REQUEST FOR INFORMATION NOT ADDRESSED IN THIS CCO REMAIN IN FORCE

CONTRACT CHANGE ORDER NO. _____
 SHEET _____ OF _____

DETAILS
SAS SUPERSTRUCTURE GIRDER WESTBOUND
PLATFORM 7 CONDUIT, LIGHTING,
AND GROUNDING PLAN
 SCALE AS NOTED
E-117

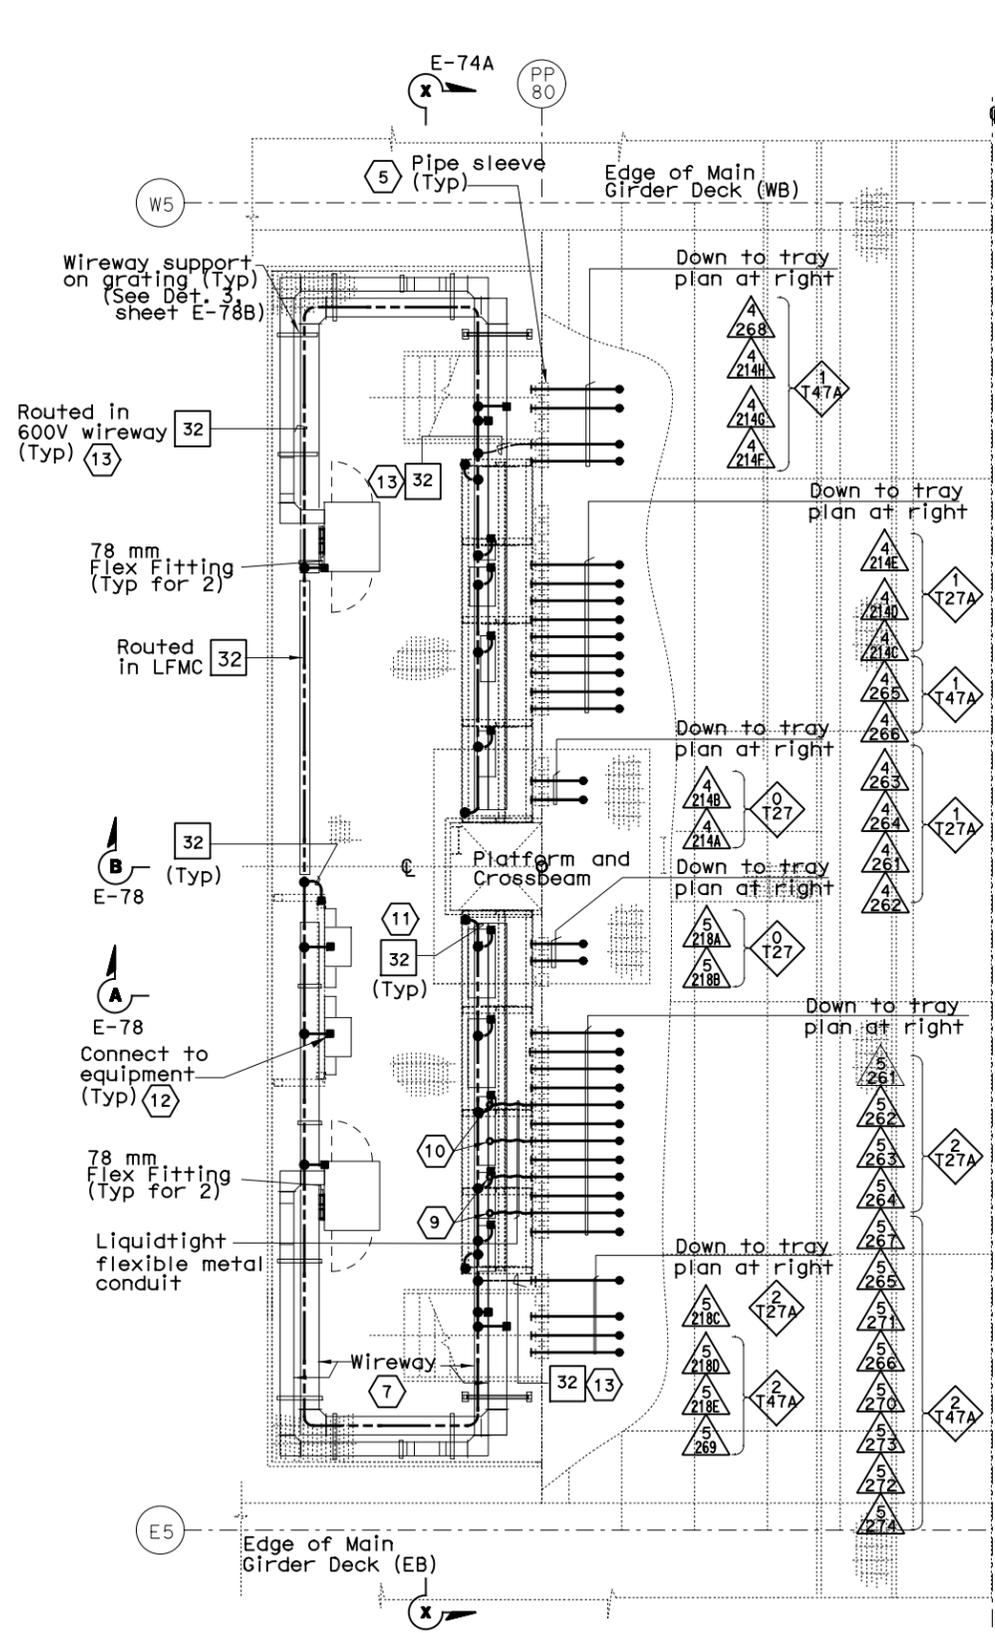
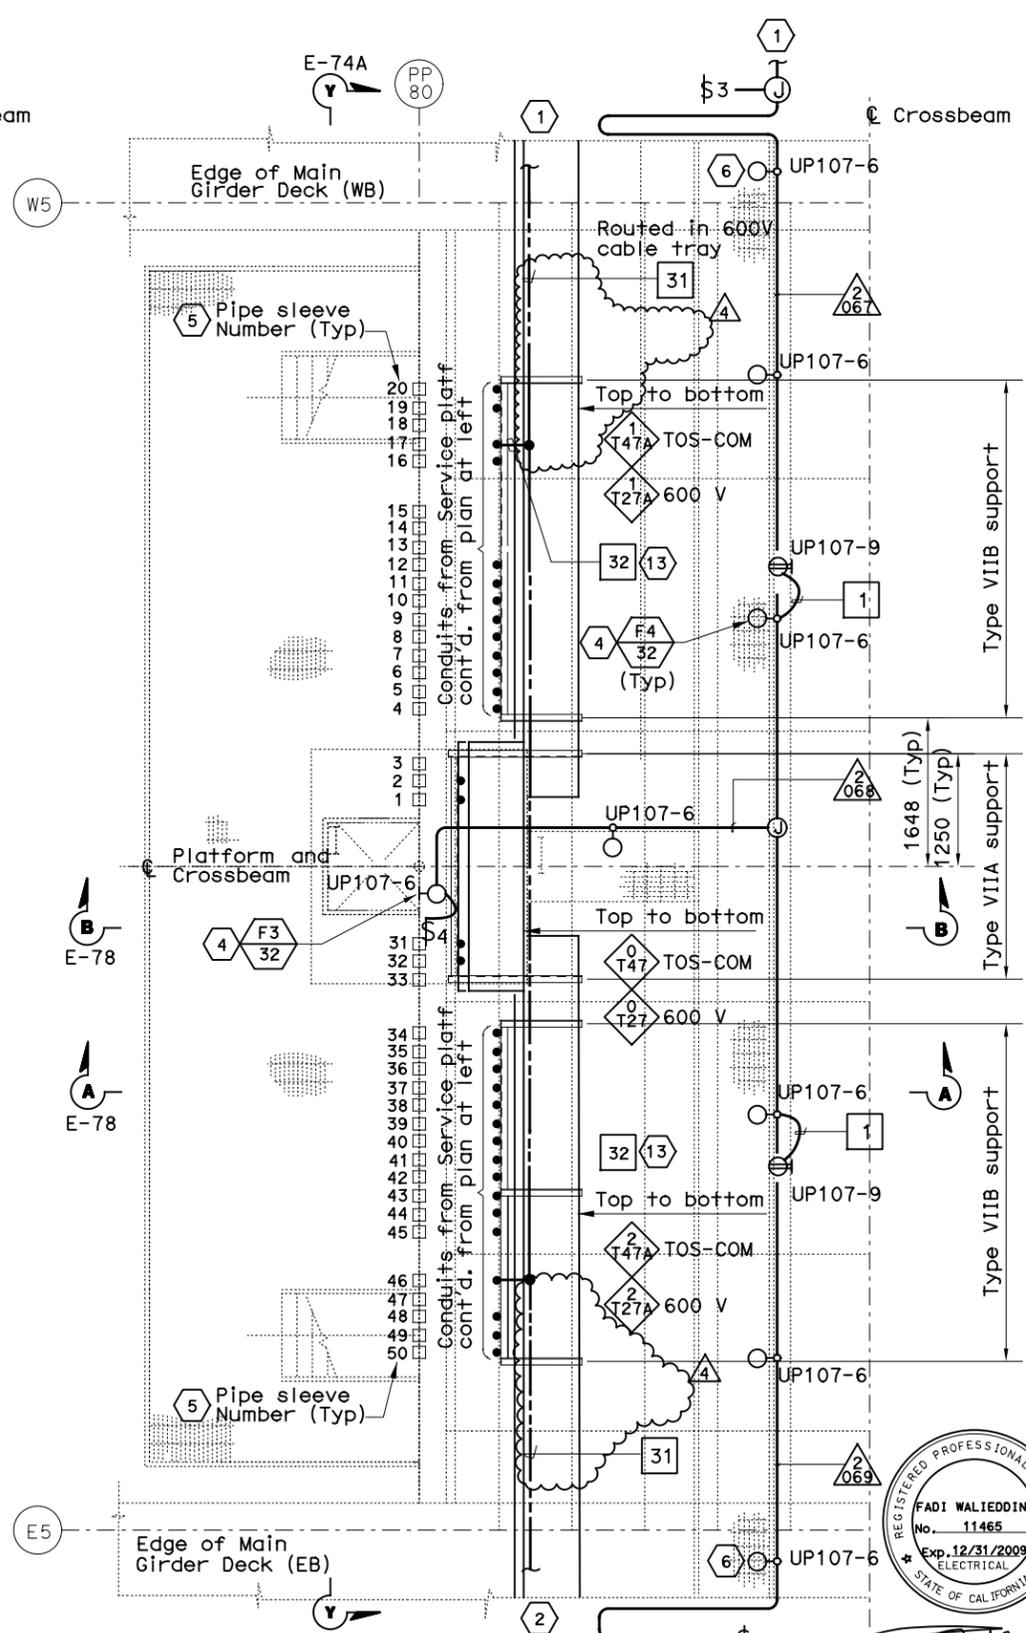
MARK	DATE	DESCRIPTIONS	BY	CH'D	CCO#
④	07/01/11	TOS MODIFICATIONS	RR	RG	81
③	11/20/09	ELECTRICAL GROUNDING	AWG RR	RG FW	75
②	06/25/09	SERVICE PLATFORM ELECTRICAL CHANGES	RR RY	RG FW	55
①	03/30/09	SERVICE PLATFORM ELECTRICAL CHANGES	RR MP	RG FW	55
